August 19, 2016
BOARD OF COUNTY COMMISSIONERS
ORANGE COUNTY, FLORIDA
IFB NO. Y17-702-CC/ADDENDUM NO. 2
REGIONAL HISTORY CENTER CHILLER & COMPUTER ROOM AIR
CONDITIONING UNIT REPLACEMENT

This addendum is hereby incorporated into the bid documents of the project referenced above. The following items are clarifications, corrections, additions, deletions and/or revisions to, and shall take precedence over, the original documents. Underlining indicates additions, deletions are indicated by ~~strikethrough~~.

SHEET INFORMATION:	
JOB No. 100048247	Date Issued: 05/31/16
Designed By: JLA	Sheet Number:
Checked By: GH	EP-101
OC Review: GH	
Phase: BID

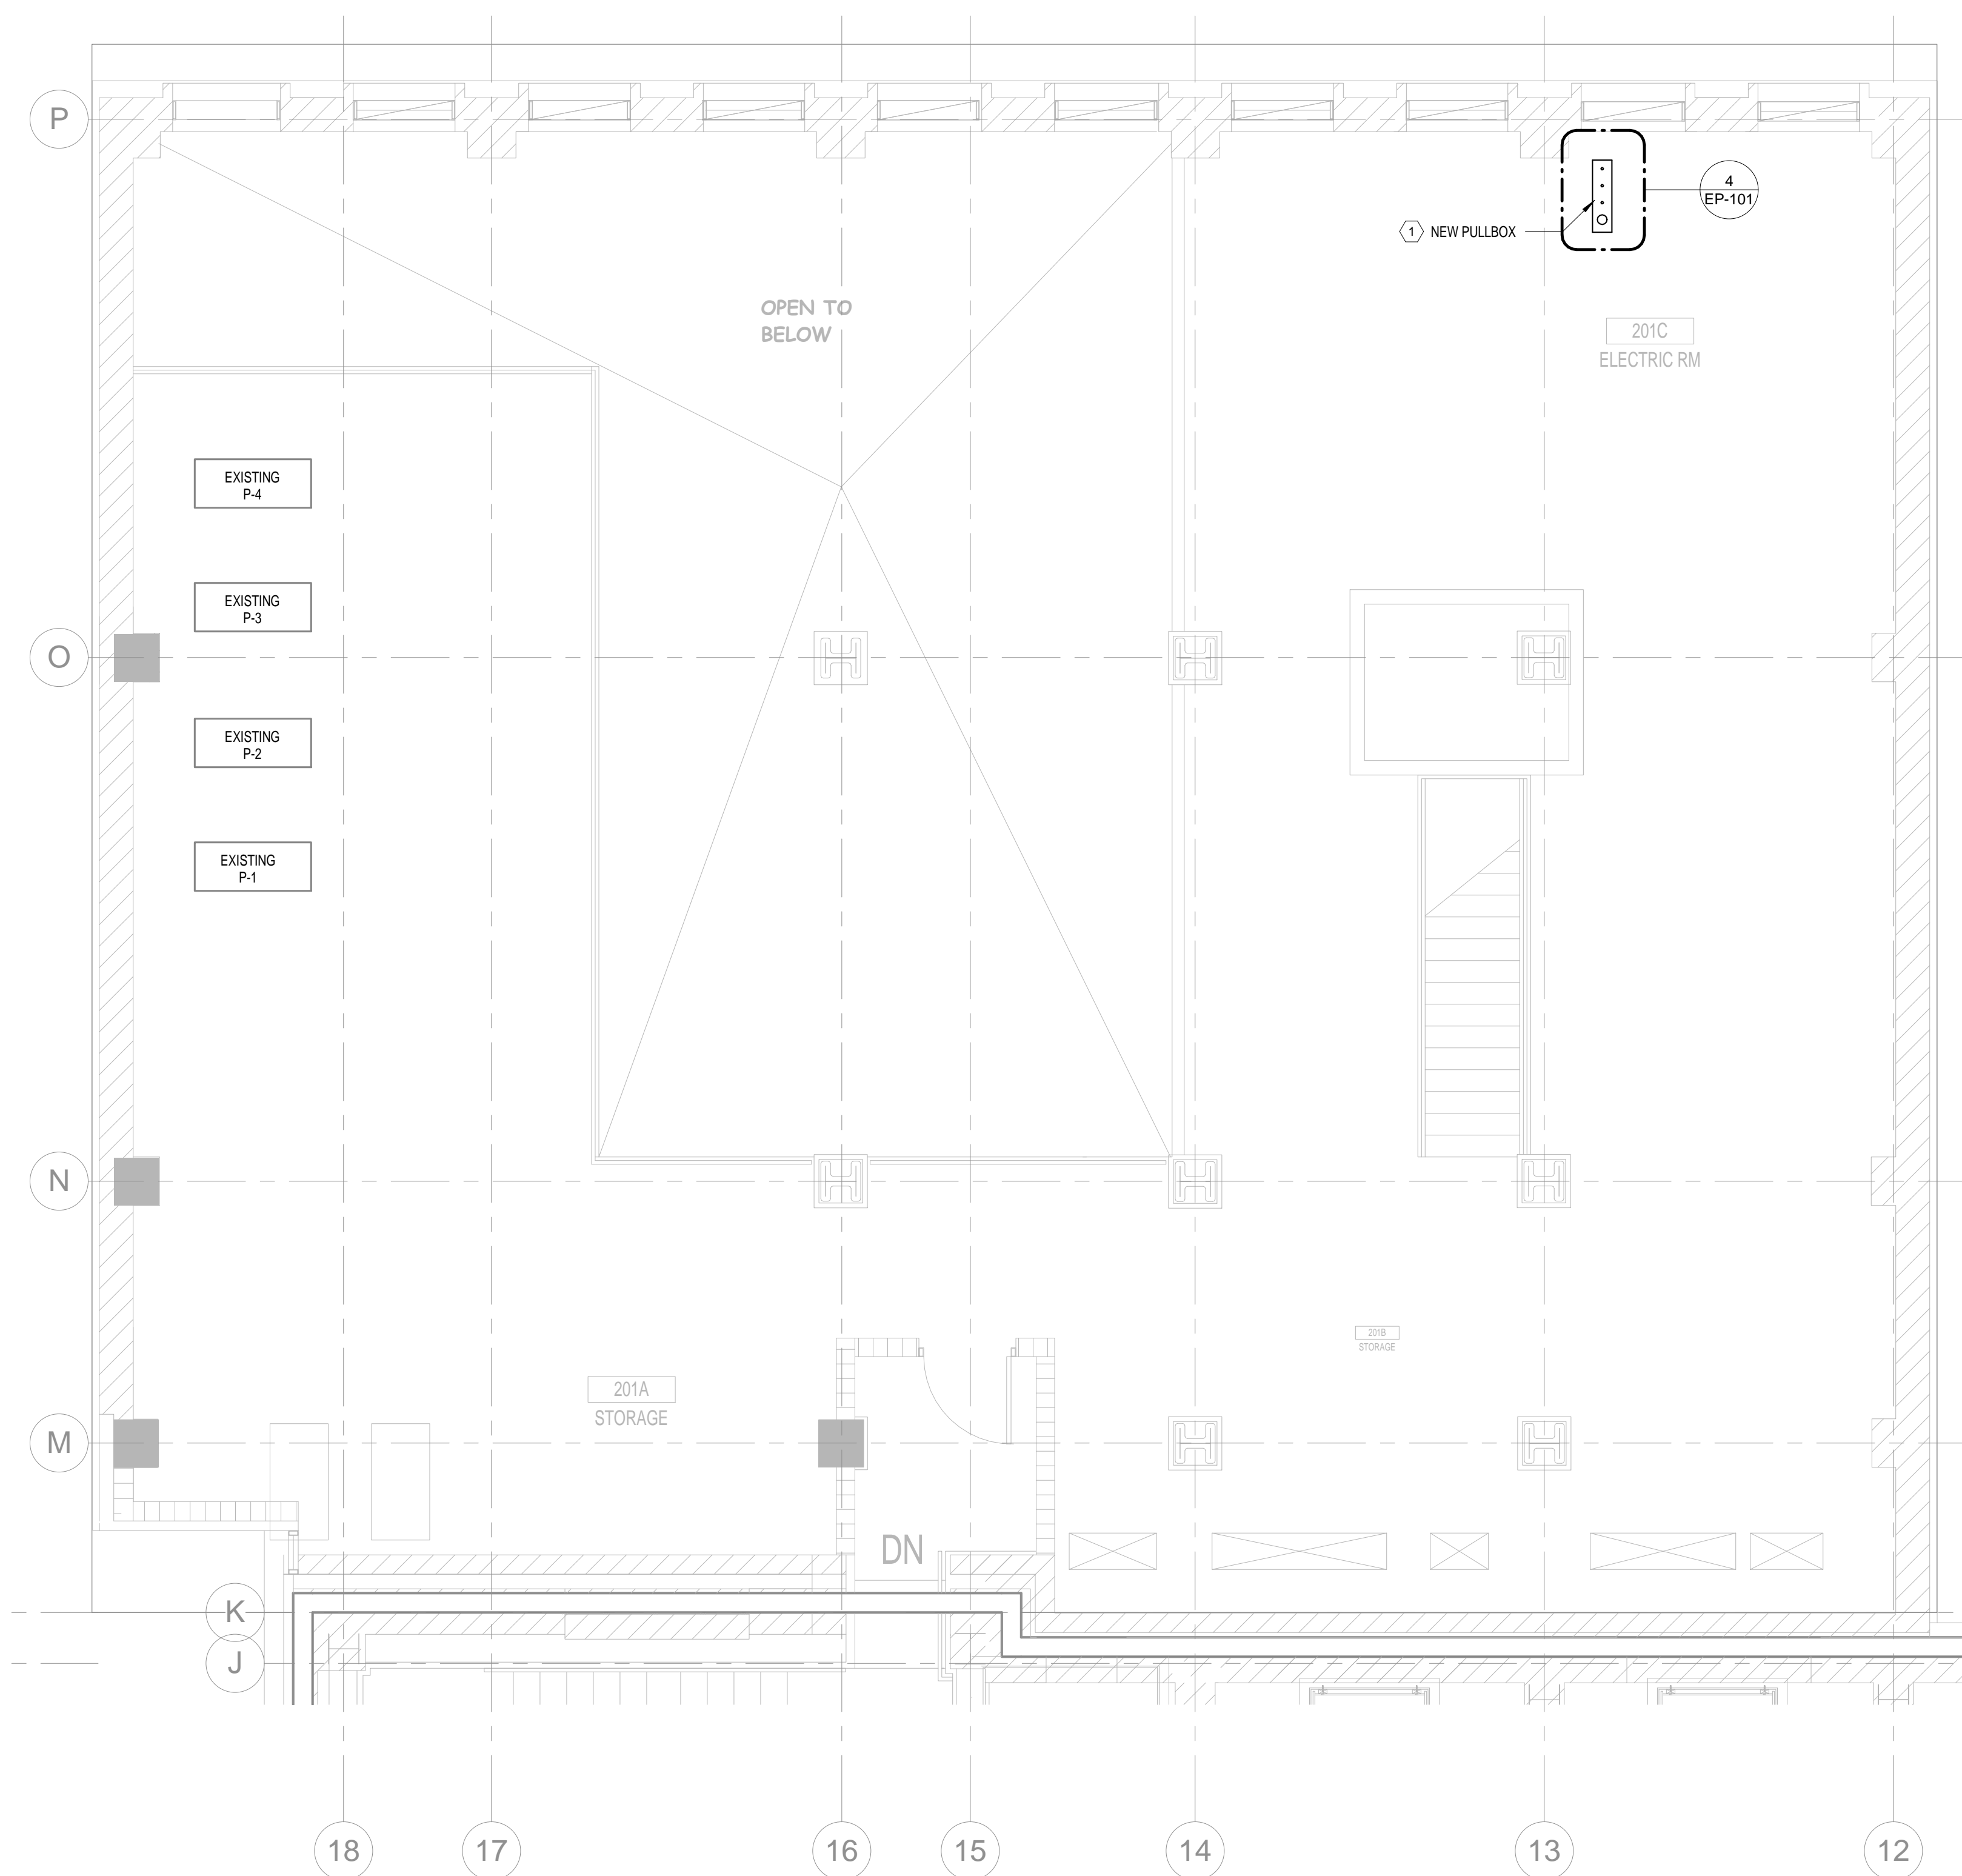
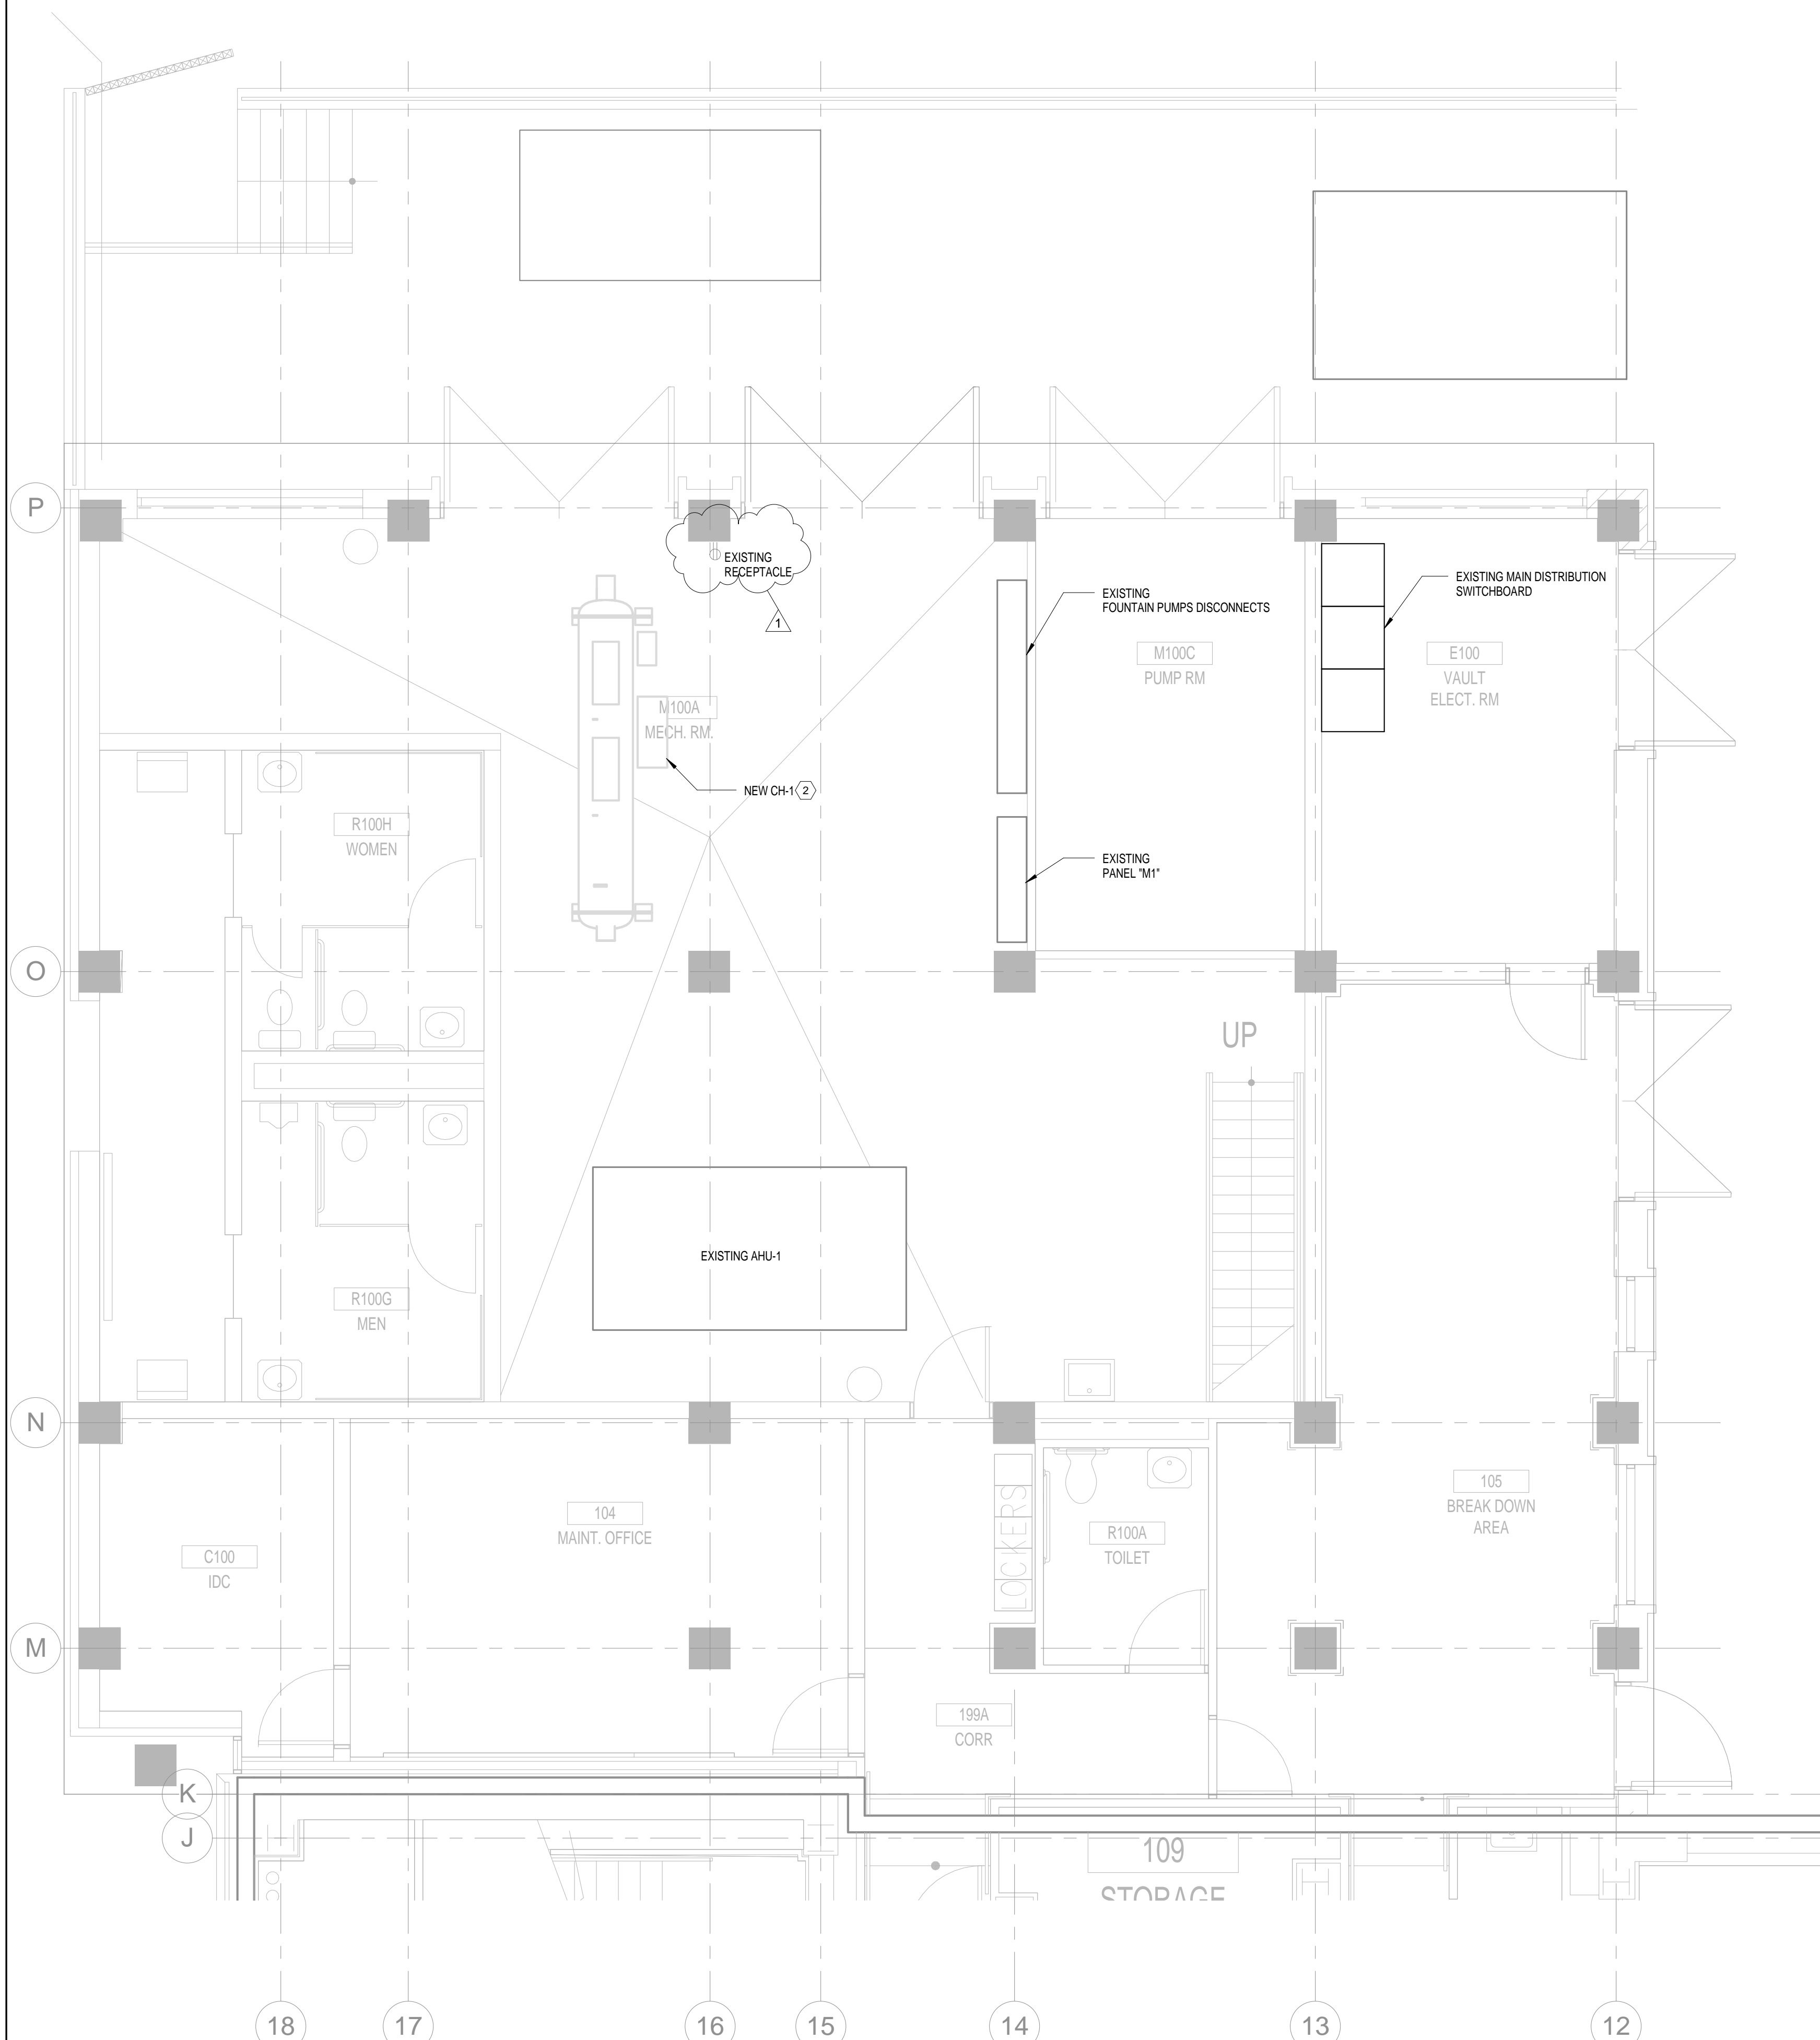
- M-202 HVAC Details (Double Door design requirements added to Detail 1. Contractor to provide Florida Product Approval.
- E-001 (Voltage drop calculations have been added. A load summary for the building main switchboard and panelboard schedule for panel EM5B have been added).
- EP-101 (Existing receptacle has been added).
- EP-102 (Existing receptacles have been added).
